CURRENT HABITAT ISSUES

DRAFT

HABITAT COMMITTEE REPORT

Klamath River FERC Relicensing Process

Figure 1. Project Reach and Above Project Reach (in red) designations for the Klamath River above Iron Gate Dam).

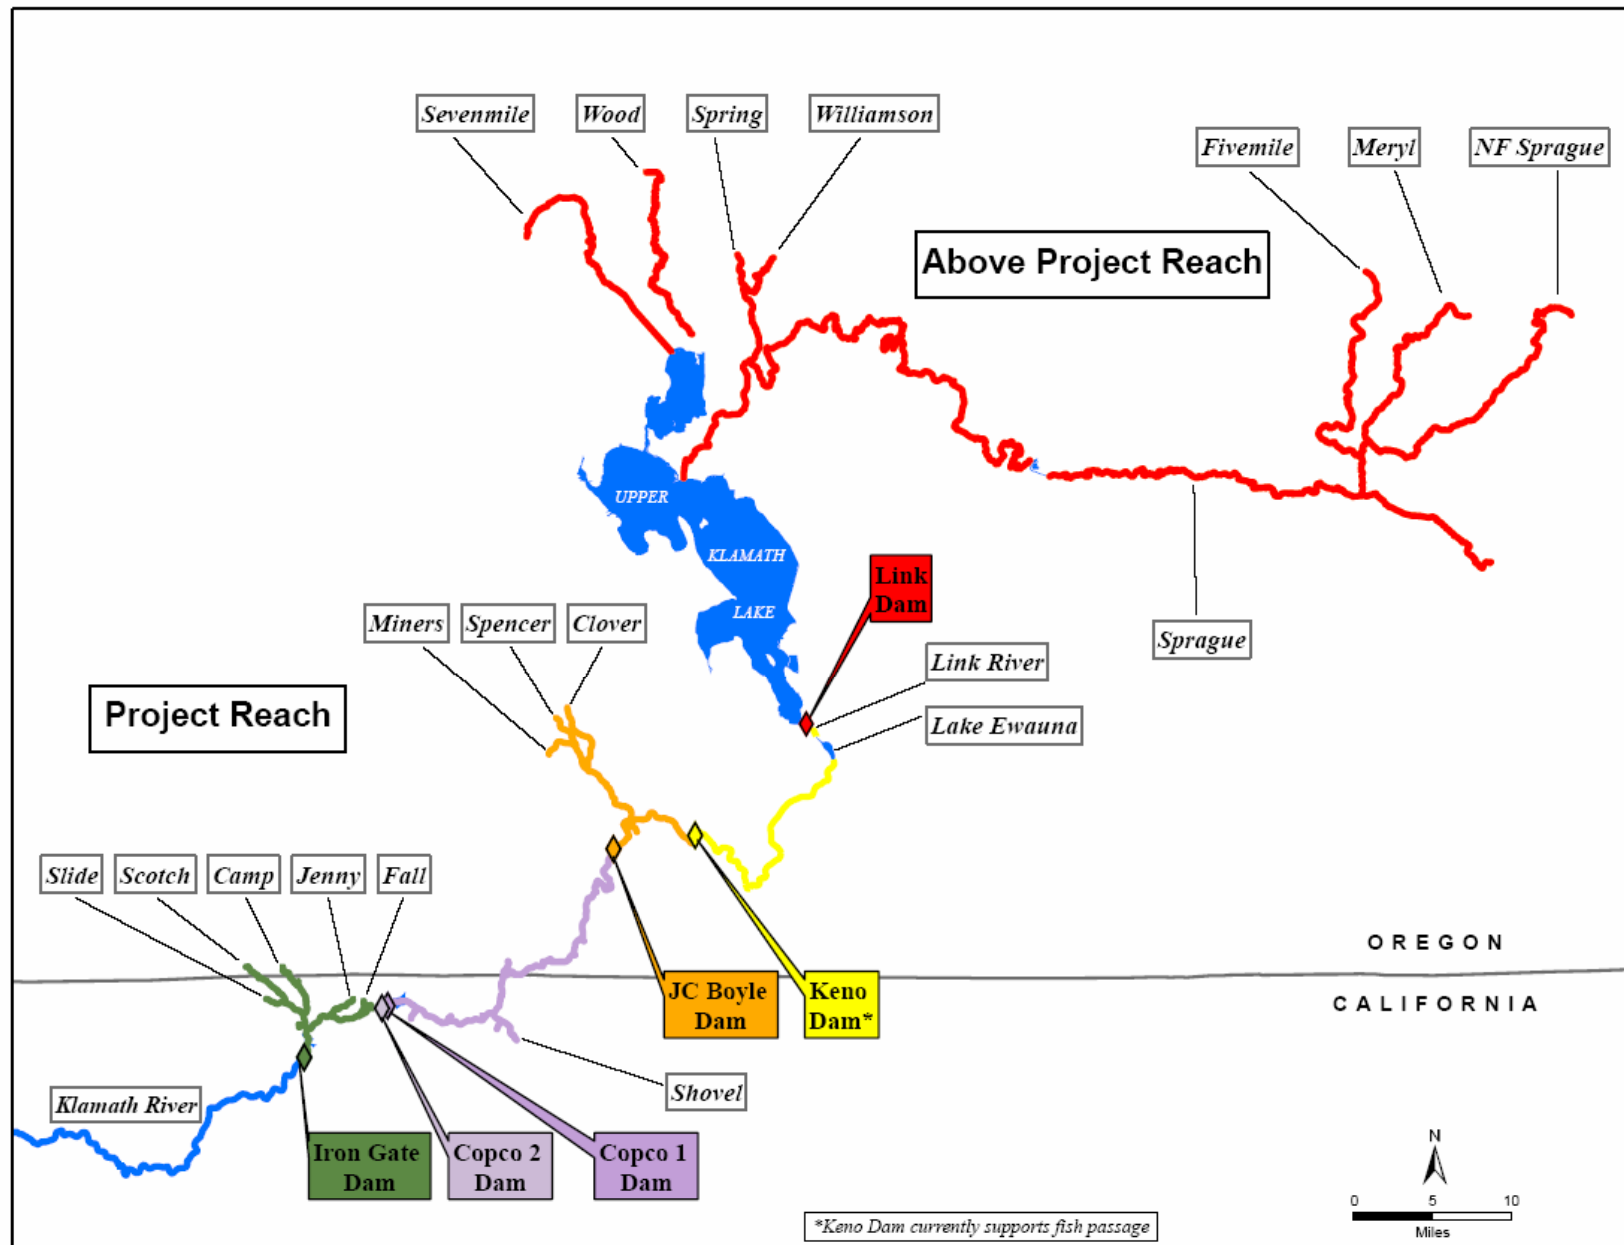
A map on page A-19 of the NMFS document shows the project area and dams. Removal of the lower four dams provides access to approximately 59 miles of anadromous fish habitat within the project area. Fish passage improvements to remaining dams provide an additional gain of approximately 360 miles of suitable habitat upstream of Keno dam.
